Product Discontinuation

PDN-IFC-4023-2019

Business Unit	Product Line Code	Type of Change	Action	Date of Issue
IFC - Industrial Field Connectivity	BF7	Product Discontinuation	Notify Distributors and Field	7/17/2019

Product Discontinuation

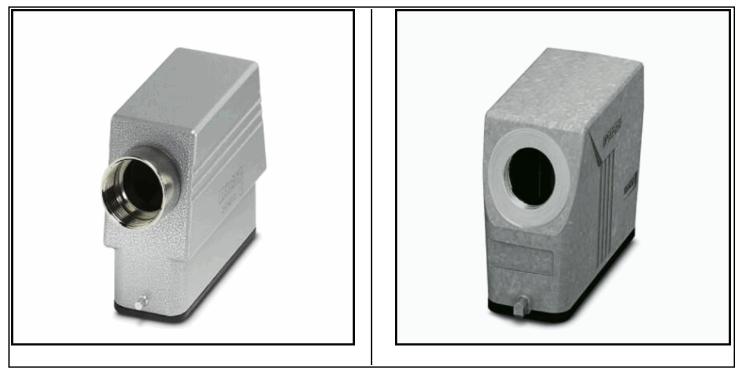
Description for Product Discontinuation Legacy D25 housings are being discontinued with the addition of our current D25 housings. Legacy housings included a powder coating and extra threaded sleeves. The current versions do not require a powder coating to achieve the same performance levels, and threaded inlets are built into the housing itself.					
Stock Status

Discontinued Part #	Type Description	Replacement Part #	Type Description
1416378	HC-D 25-SMLD-57/O1PG21	1424399	HC-STA-D25-SLWSC-2SSP21-EL-AL
1604904	HC-D 25-TFL-72/O1M25G	1424382	HC-STA-D25-HHFS-1TTM25-ELC-AL
1604969	HC-D 25-TFL-72/O1M25S	1424377	HC-STA-D25-HHFS-1STM25-ELC-AL
